Conditions of Approval:

PLUG AND ABANDONMENT PROCEDURE

Ute Indian A #36

Conditions of Approval - Notice of Intent to Abandon:

Proposed P&A

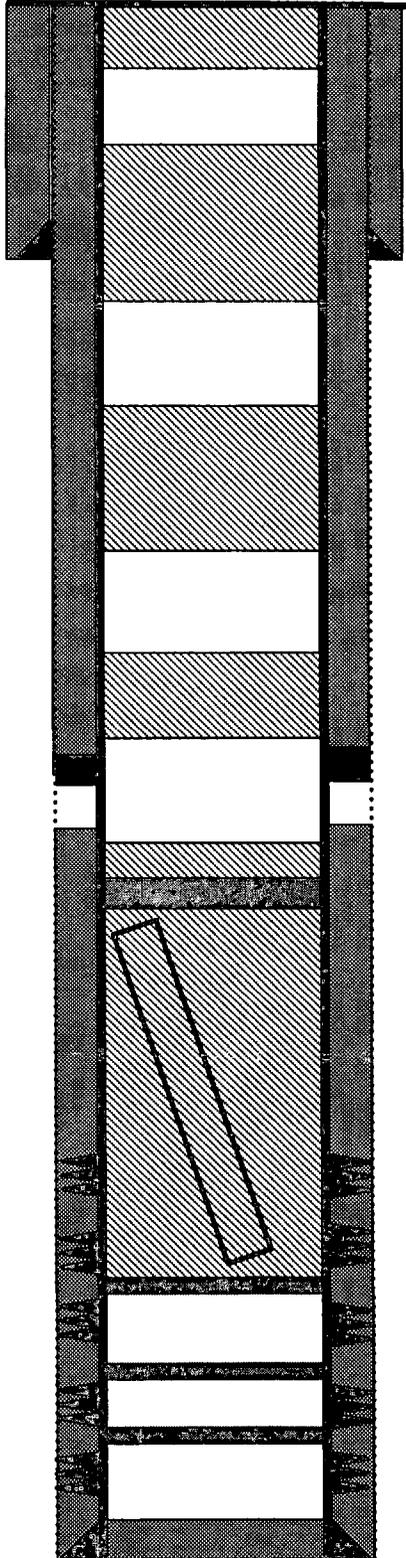
Add Entrada plug from 3570 to 3470

Extend Dakota plug to 2172 to cover Graneros top

Add Gallup plug from 1540 to 1440

- 6c). **Surface plugs must be a minimum of 50 ft. within casing and annular voids. Onshore Order #2.III.G.6.**
 - 6d). **Add an additional 100 ft. plug (both inside and outside the casing) at approximately 4613 ft. This will break up a long run that has no cement inside and outside the production casing.**

- 6e). **Tag Balanced plug #4.**
